RESIDENCE RENOVATION AND ADDITION  
7801 ZIMPLE STREET  
NEW ORLEANS, LOUISIANA

12/22/25  
A - 1

### ROOF DEMOLITION PLAN

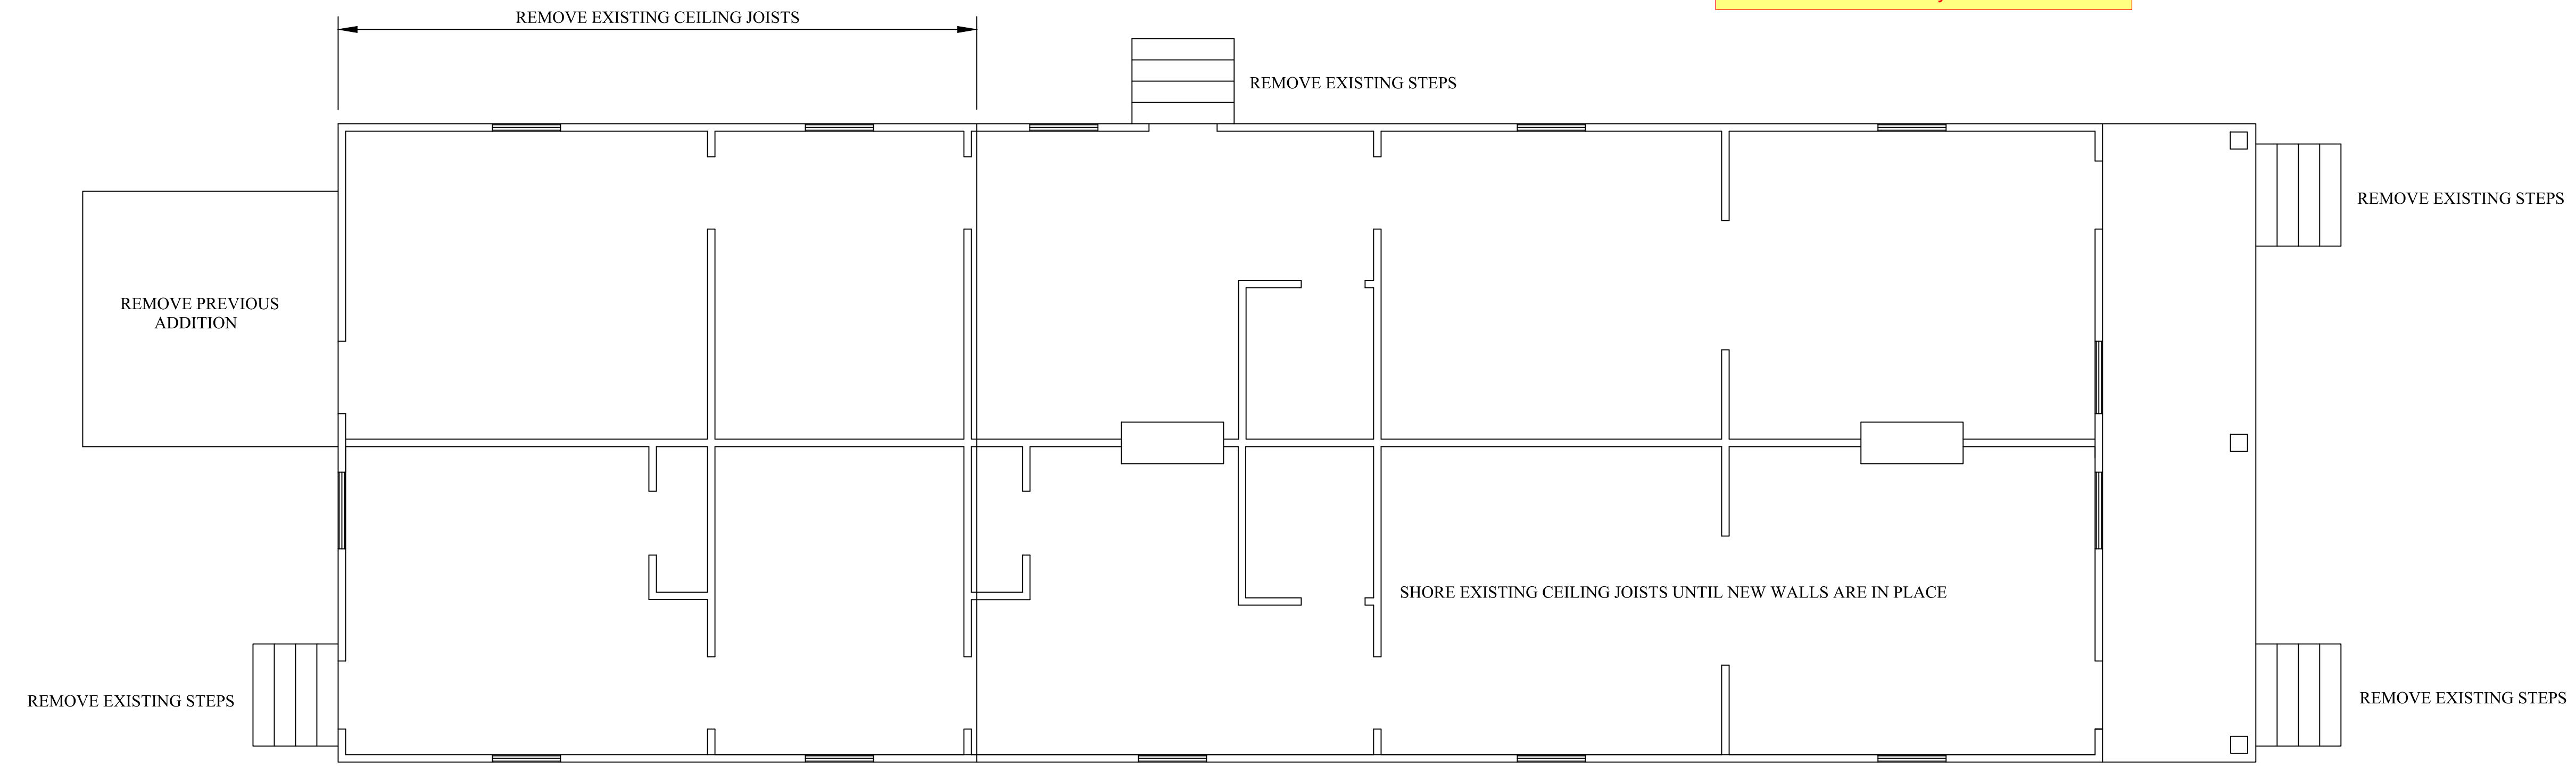
Partial roof demolition to accommodate new camelback addition approved by CMM at the 12/03/2025 meeting and upheld by City Council at appeal on 01/27/2026.

HDLC Roof Demolition Calculations:  
Total Roof Area = 1967.48 SF  
Total Roof Area Demolished = 1092.73 SF = 55.5%

1/4" = 1'-0"  
TOTAL ROOF AREA = 2013.71 SQUARE FEET  
TOTAL ROOF AREA DEMOLISHED = 1126.67 SQUARE FEET = 55.9%

**PROPOSED FRONT ELEVATION**  
 1/4" = 1'-0"

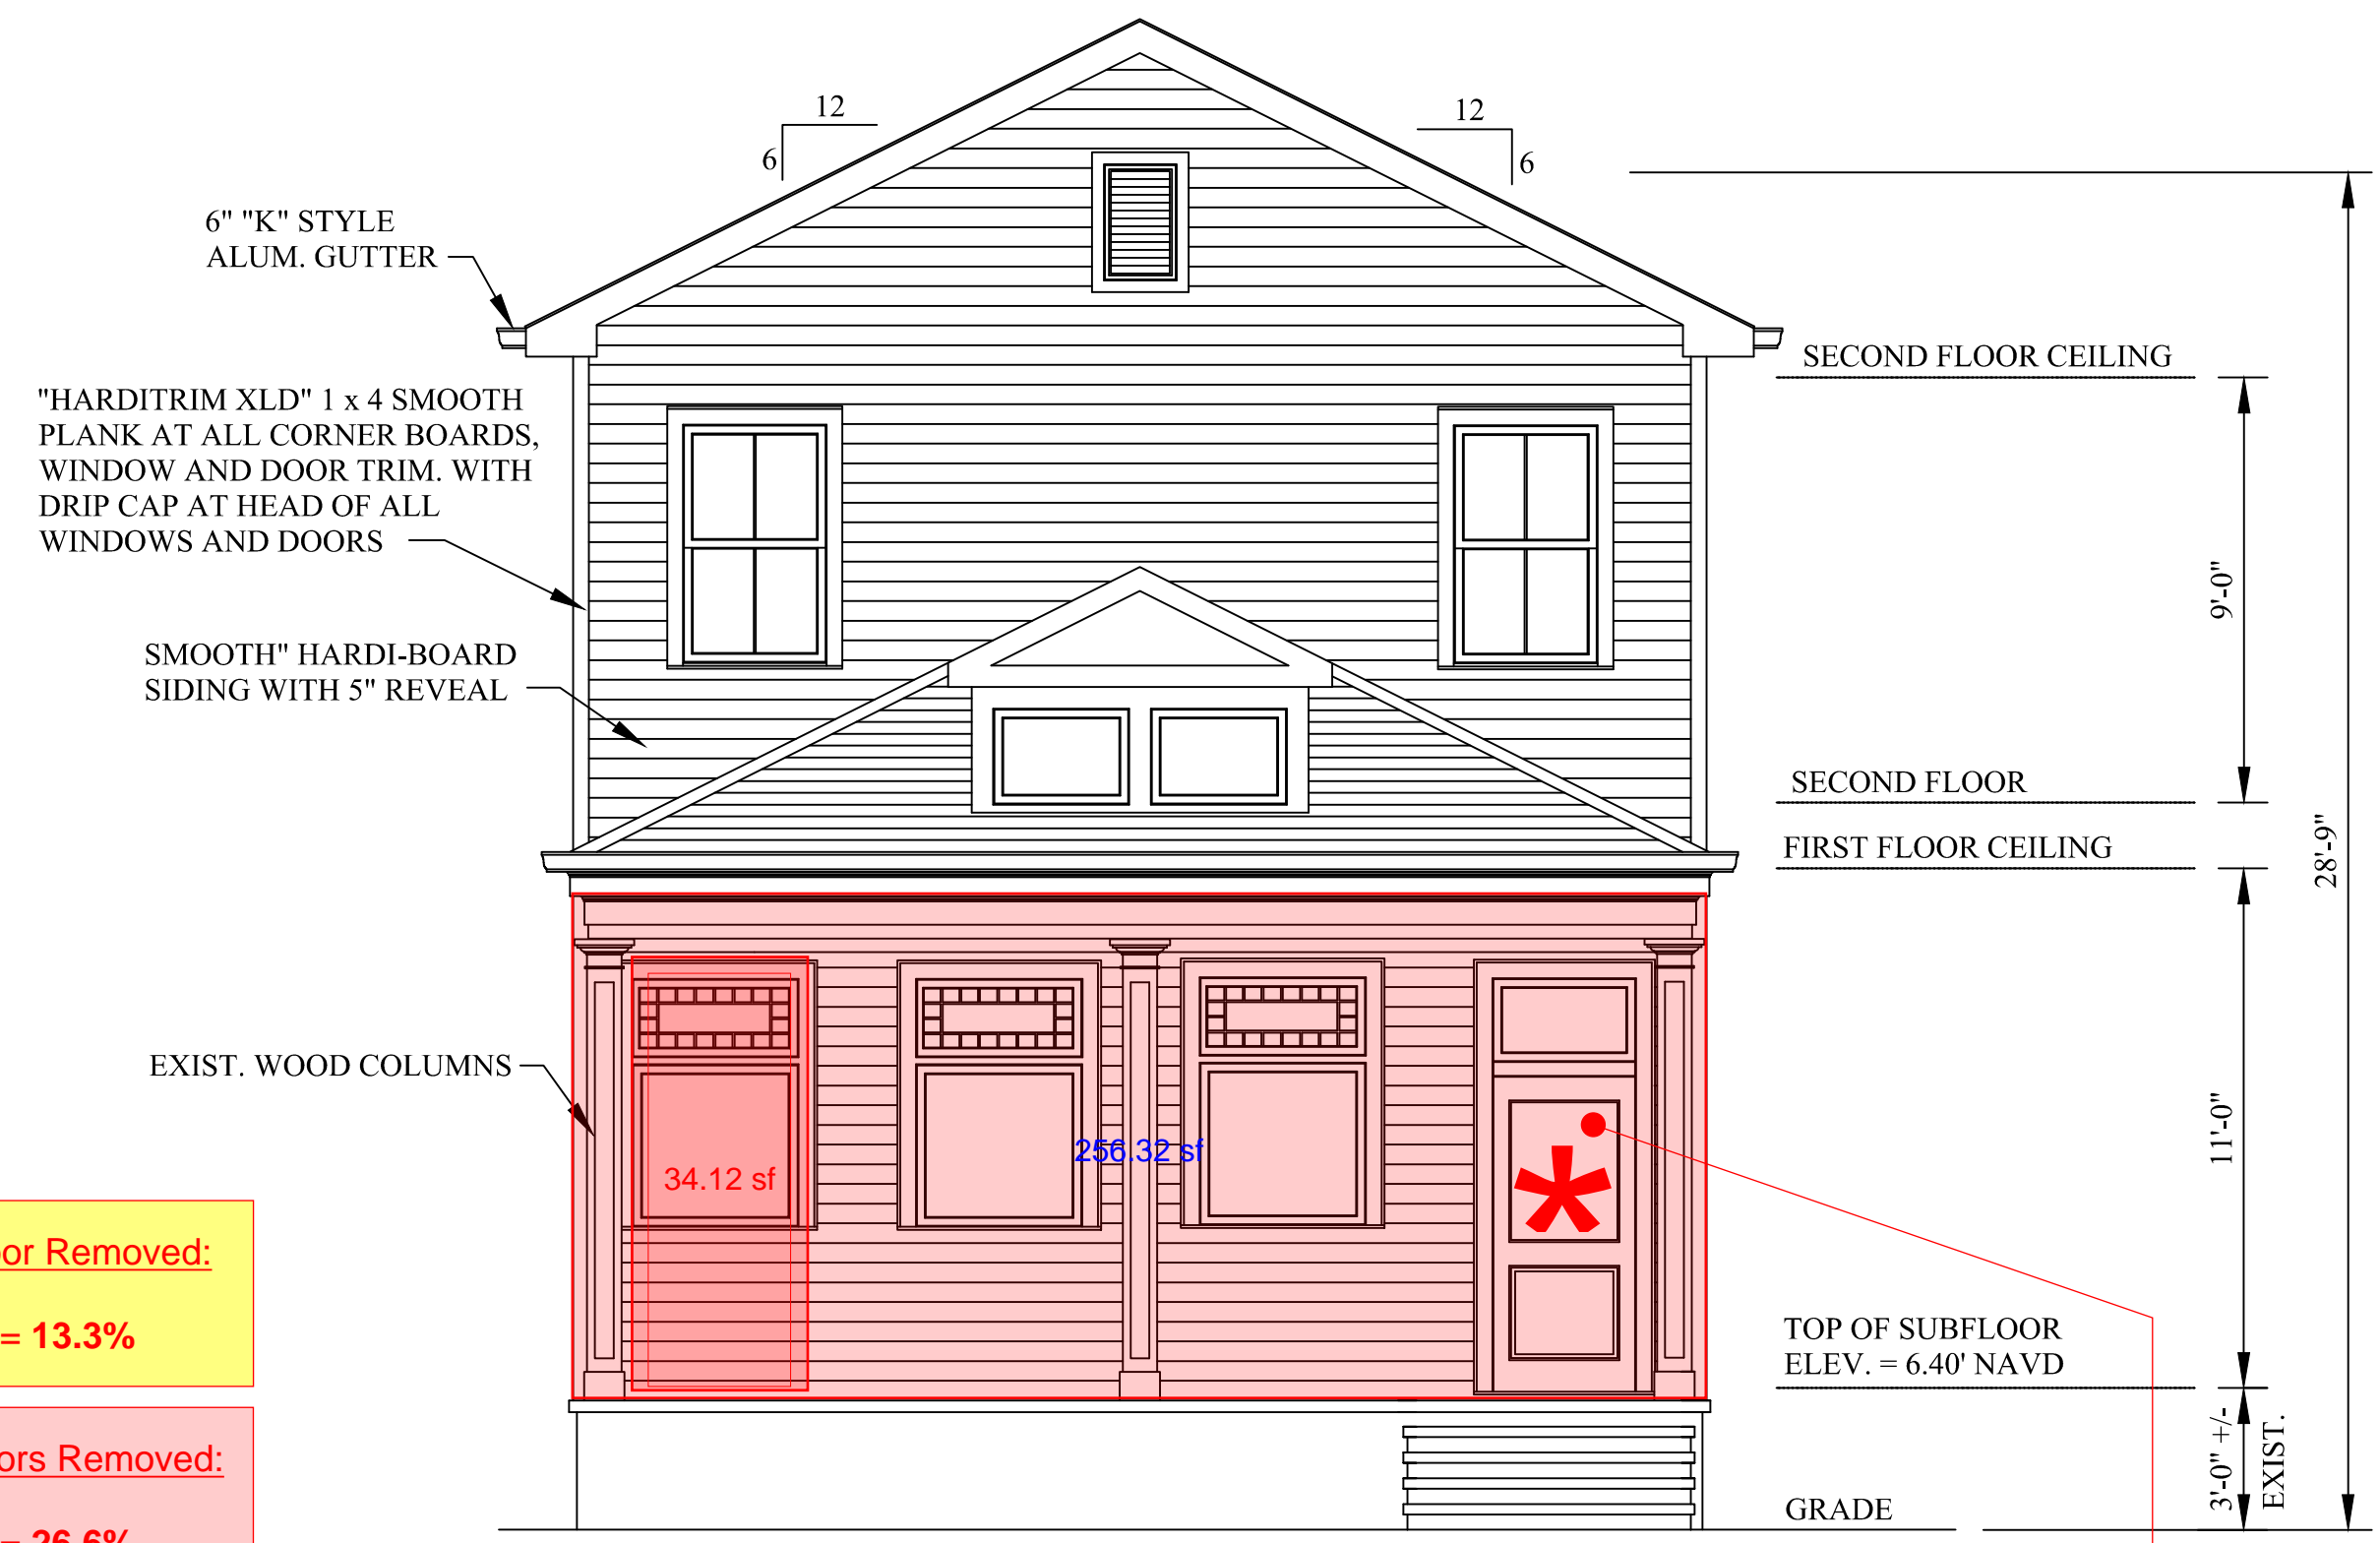
- Existing right-side door and central window sizes, locations, and header heights to remain the same
- Remove one existing door and transom from left side opening for replacement with new window that matches the adjacent existing windows in sill/header height and width, etc. (replication of new decorative wood multi-light transom above window is recommended by HDLC but is not required)
- HDLC also recommends retaining/maintaining the existing decorative wood multi-light transom above the right-side door opening to remain (but is not required)
- Removal/replacement or modification of right-side door opening size, location or door/transom is considered partial facade demolition and will require additional HDLC approval prior to commencement

HDLC Facade Demolition Calculations - One Door Removed:  
 Total Facade Area = 256.32 SF  
 Total Facade Area Demolished = 34.12 SF = **13.3%**

HDLC Facade Demolition Calculations - Both Doors Removed:  
 Total Facade Area = 256.32 SF  
 Total Facade Area Demolished = 68.24 SF = **26.6%**
